Transport for London

Lambeth Bridge northern roundabout

Response to consultation

January 2013

Please see the enclosed diagram for further information on the proposals.

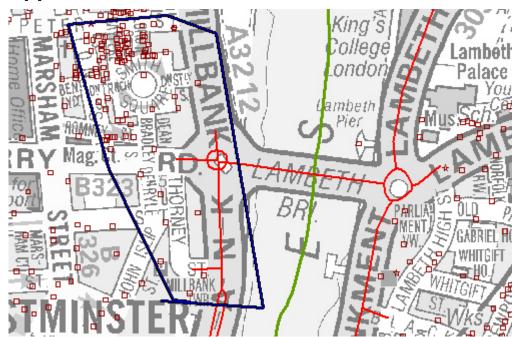
73% of 219 respondents objected to the proposals or parts of the proposals. The most common reasons for this were:

- Concerns about shared space for pedestrians and cyclists on the pavement (see below)
- Concerns that the proposed measures were insufficient, and should be replaced by more substantial segregated provision for cyclists.

93% of 120 respondents raised concerns about the proposed sections of shared space footway for pedestrians and cyclists. The most common reasons for this were:

- Concerns about potential conflict between pedestrians and cyclists
- Concerns about potential conflict between cyclists and motorists when cyclists rejoin the main carriageway
- Slow and inconvenient route for cyclists
- A small number of respondents welcomed the option of being able to cycle on the footway.

- 86% of 36 responses expressed support for the raised zebra crossings. The main reason for this was that respondents felt they would help slow down motorists approaching the roundabout
- Guide Dogs for the Blind expressed concerns that blind and partially-sighted people currently rely on the difference in gradient when identifying the road edge, and that removing this distinction would increase danger
- A small number of respondents expressed concerns that the raised crossings would slow down cyclists and make for less comfortable journeys.

- 60% of 35 responses objected to the proposed kerb build-outs, including the Motorcycle Action Group and Westminster City Council. The main reason given was that paving over the hatched areas would reduce the amount of available carriageway space for vulnerable road users such as cyclists and motorcyclists
- 37% of 35 responses supported the kerb build-outs. The main reason given was that they would help reduce speeds on the roundabout.

- 67% of 16 responses objected to the provision of blue CS8 logos on the roundabout carriageway. Reasons given included that the logos did not affect motorist behaviour, impacted on the streetscape, and were not a suitable alternative to providing dedicated cycle space.
- 25% of 16 responses supported the provision of blue route logos in order to raise motorists' awareness of cyclists.

98% of 140 responses requested a segregated cycle facility around the edge of the roundabout, separated from motorists either physically or with road markings, and physically separated from pedestrians. Some respondents felt that cyclists should be given priority over motorists as the cycle track crossed each arm of the roundabout. A number of responses endorsed other designs posted on the internet, including one posted on the London Cycling Campaign's website during the consultation period (<u>http://lcc.org.uk/articles/cyclists-say-redesign-of-lambeth-bridge-northern-roundabout-must-follow-go-dutch-principles</u>).

68 responses requested that the existing two lane flare on the roundabout approaches be reduced so that entry and exit is reduced to a single lane. Common reasons cited were that such a layout would reduce traffic speeds and potential for conflict. A number of responses endorsed the design suggested on the London Cycling Campaign's website.

61 responses requested for the roundabout to operate with one general traffic lane instead of two as at present. Respondents felt that this would reduce traffic speeds and provide more space for cyclists. Again, a number of responses endorsed the London Cycling Campaign's suggested design.

14 respondents requested for the CS8 cycle lanes on Millbank to be extended through the zig-zag markings up to the zebra crossings in order to provide more space for cyclists and reduce conflict between cyclists and motorists.

13 respondents, including London TravelWatch, Guide Dogs for the Blind, and the Westminster Cycling Campaign, suggested that the roundabout be replaced by a conventional signalised junction. The most common reasons for this were that it would reduce conflict between cyclists and motorists and would allow the provision of signalised pedestrian crossings.

The proposed early benefit scheme at Lambeth Bridge northern roundabout was designed to provide improvements for cyclists, whilst also allowing TfL to continue exploring further, more radical improvements to improve facilities at this location. The proposals were developed following careful analysis of casualty statistics at the roundabout and a thorough review of the current physical road layout. However, having considered responses to consultation, and following concerns voiced by Westminster Council, we have decided not to proceed with these planned initial improvements at Lambeth Bridge northern roundabout. Instead, we will concentrate our resources on developing more substantial improvements that meet the expectations of Westminster Council and other stakeholders.

Some of the measures suggested by respondents, such as a segregated cycle track around the outside of the roundabout with cyclist priority at slip roads, would be new features on London's roads, and therefore require off-street trials. We have started building the infrastructure for these trials at the Transport Research Laboratory in Berkshire, and we will work with our stakeholders to ensure their views are considered as part of this work. Suggestions made as part of this and other consultations will be considered by the team planning the trials.

A roundabout with a segregated cycle track around its perimeter and cyclist priority across traffic lanes would be a new feature on London's roads. It would therefore require off-street trials. We have started building the infrastructure for these trials, and we will work with our stakeholders to ensure their views are considered as part of this work.

We will consider this aspiration as part of our work to trial roundabout layouts with segregated cycle lanes.

Moving the zebra crossings closer to the roundabout would mean that traffic exiting the roundabout would block the circulatory carriageway whilst waiting for pedestrians.

Having considered the comments received, we intend to proceed with plans to trial a roundabout with segregated cycling provision, as opposed to replacing the roundabout with a conventional 4-way junction.

We are currently developing proposals for a 20mph speed limit at the Waterloo (IMAX) roundabout. We will monitor and evaluate this work before considering similar proposals.

The footway on Lambeth Bridge is scheduled to be replaced as part of our 2013/2014 programme of footway works.
